**CALENDAR ITEM
C73**

**CONSIDER AMENDMENTS TO BALLAST WATER PERFORMANCE STANDARDS
REGULATIONS TO ESTABLISH PROTOCOLS FOR THE EVALUATION OF
COMPLIANCE WITH CALIFORNIA BALLAST WATER DISCHARGE STANDARDS**

TEXT OF MODIFIED REGULATIONS

**Title 2, Division 3, Chapter 1,
Article 4.7 Performance Standards and Assessment Protocols for the Discharge
of Ballast Water for Vessels Operating in California Waters**

Figure 1. Sampling port components and dimensions

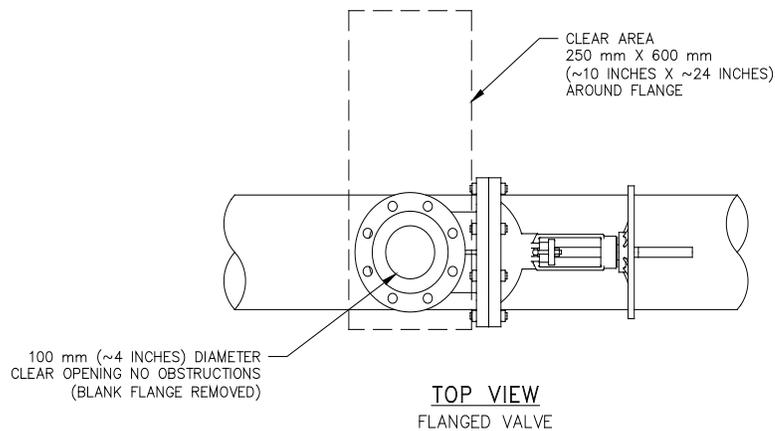
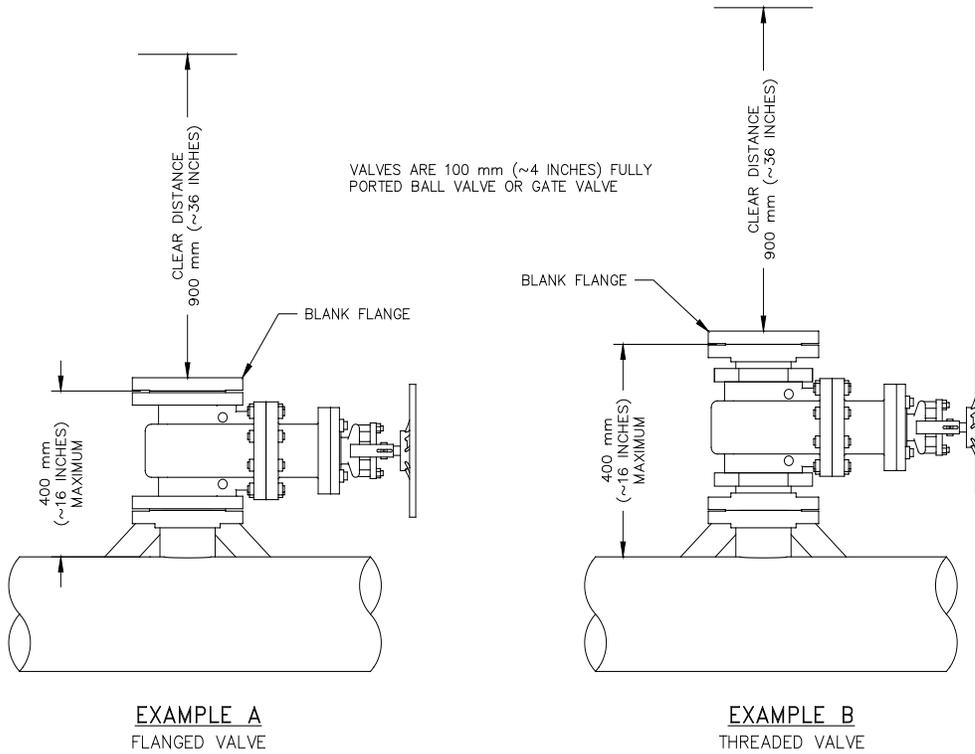
1) The sample port(s) provided by the vessel shall consist of a piping connection into the ballast main, a shut-off valve, and a flange. All other sampling and test equipment is to be provided by the Commission staff performing the sampling and testing.

Sample port size shall be based on the combination of maximum sample flow rate and minimum ballast flow rate that yields the largest isokinetic diameter. All sample port components shall be at least four inches (100 mm) in nominal dimension and comply with the materials schedule of the existing ballast water system.

C) 3) The opening of the sampling pipe shall be chamfered to provide a smooth and gradual transition between the inside and outside pipe diameters. The sample port shall consist of the following components (see Figure 1 – Sampling port components and dimensions):

i. A branch connection, using a tee fitting, pipe boss, saddle, or other approved method shall be used to access the inside of the ballast water main pipeline. The inside of the access shall be unobstructed by the ballast main pipe, internal edges filed smooth, and de-burred.

ii. An isolation valve that meets marine vessel regulatory requirements as mandated by the relevant flag state and/or marine classification society shall be provided to allow the sample port to be closed off from the ballast main pipeline. The isolation valve shall be fully ported, such that a clear and straight opening equal to the pipe inside diameter is provided from the access flange into the ballast main. Suitable valves include fully ported ball valves and gate valves. Butterfly, globe, and similar valves that do not provide a clear and straight opening are not acceptable.

iii. An access flange shall be provided to allow connection of Commission equipment to the access port. The access flange shall be of standard design such as ANSI B16.5 or DIN equivalents. It is acceptable to utilize a flanged isolation valve as the access flange. The access flange must be paired with a blank flange, gasket, and bolting suitable to close the sample port. The access flange must be maintained such that Commission gaskets can fit tightly when sampling equipment is attached.

iv. The distance from the ballast main pipe inside diameter to the face of the access flange shall not exceed 400 millimeters (mm) (approximately 16 inches).

v. A minimum of 900 mm (approximately 36 inches) of clear operating area above the access shall be available for the attachment of Commission sampling equipment.
